ADDENDUM NO_1 US 50 and I-77 IC Bridge Beam addition

Solicitation Number: CRFQ 0803 DOT2200000105

Addendum 1

US 50 and I-77 Bridge Beam Addition

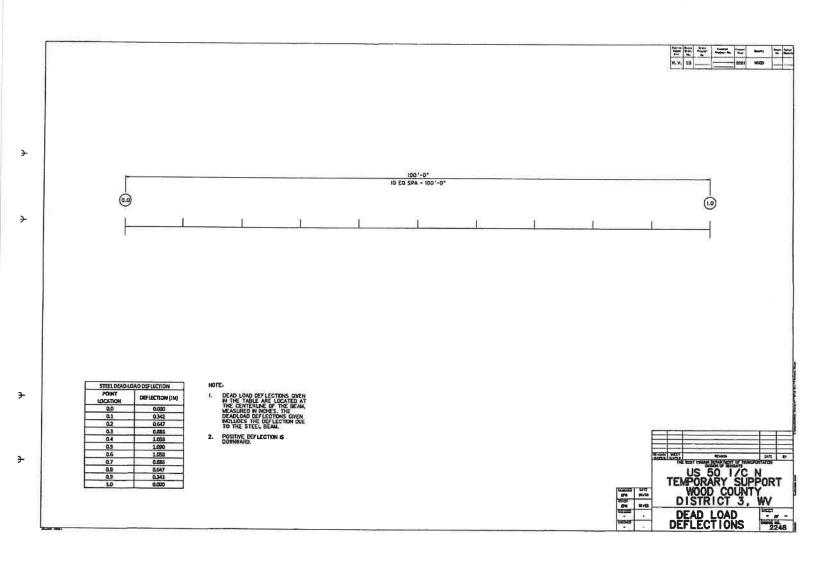
Is there any camber required for the beam?

The beam shall be cambered for its own dead weight (i.e. only the dead weight of the

steel). See attached dead load deflection drawing.

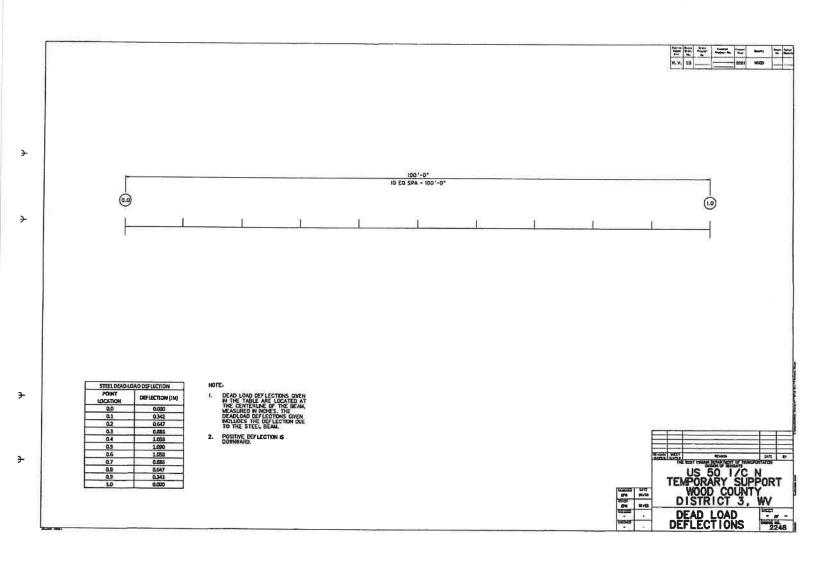
Is there any camber required for the beam?

The beam shall be cambered for its own dead weight (i.e. only the dead weight of the

steel). See attached dead load deflection drawing.
